Terminal Tractor Service Bulletin

Subject: Block Heater Relay – USPS Trucks			
Product: Medium Terminal Tractor	Bulletin # SB18TI0098	Date: 09-Nov-2018	Pages: Page 1 of 6
To: All Kalmar Sales Companies		From: Medium Terminal Tractor Product Support

Units Affected: United States Postal Service trucks with serial numbers 347330 through 347705

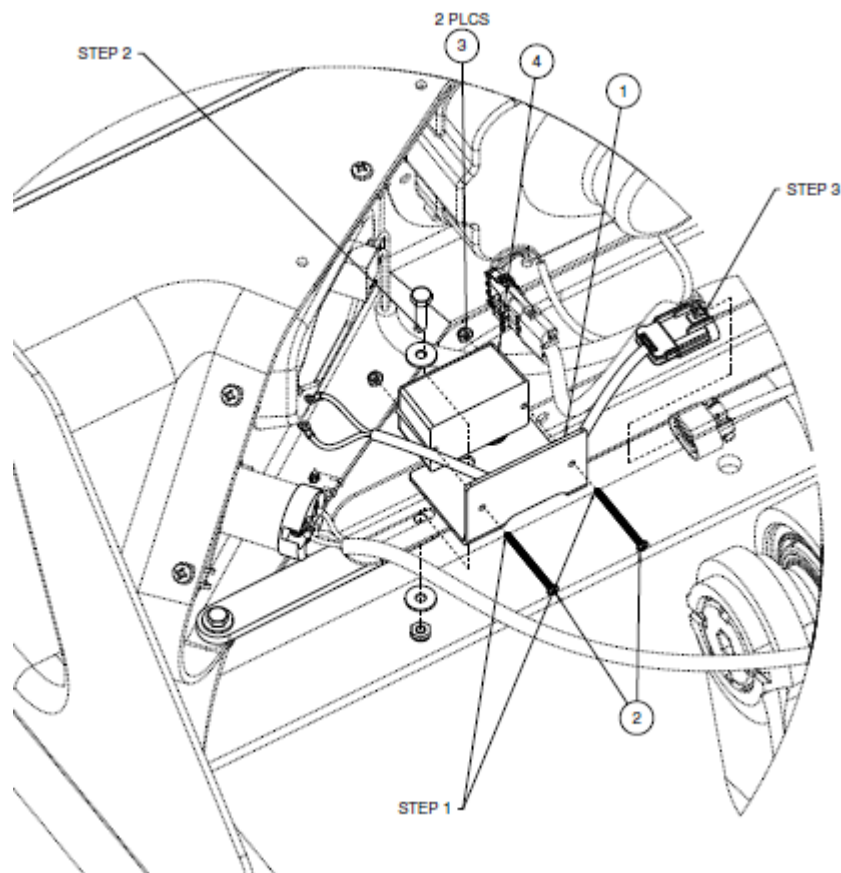
6. Disconnect the ACIR plug on the other wire coming from the relay.
7. Remove the 5/16 bolt securing the relay bracket to the headlight stabilizer bar. Discard the relay and mounting bracket.

Note: Keep the mounting hardware.

New block heater relay installation

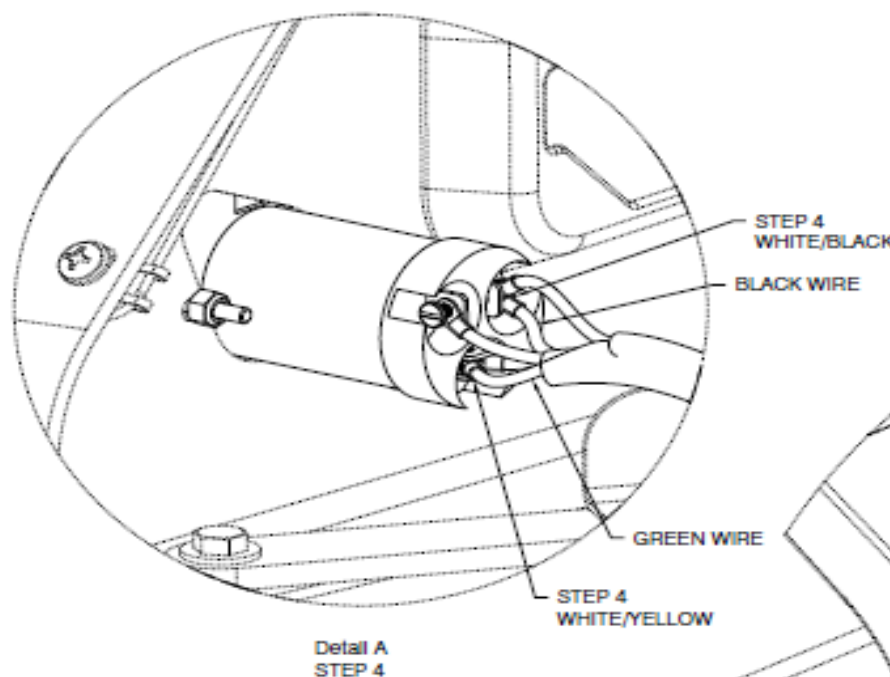
1. Insert wires of the relay (ITEM 4) through the hole in the mounting bracket (ITEM 1). Secure items 1 and 4 using items 2 and 3.
2. Secure the new relay and bracket to the headlight support using the 5/16 hardware removed when taking out the old relay.
3. Reconnect the ACIR plug.

4. Slide the harness through the boot and connect as shown. (White/Black with Black and Green with White/Yellow)
5. Slide the rubber boot over the wires and back into place.
6. Reconnect the batteries, and lower the cab.
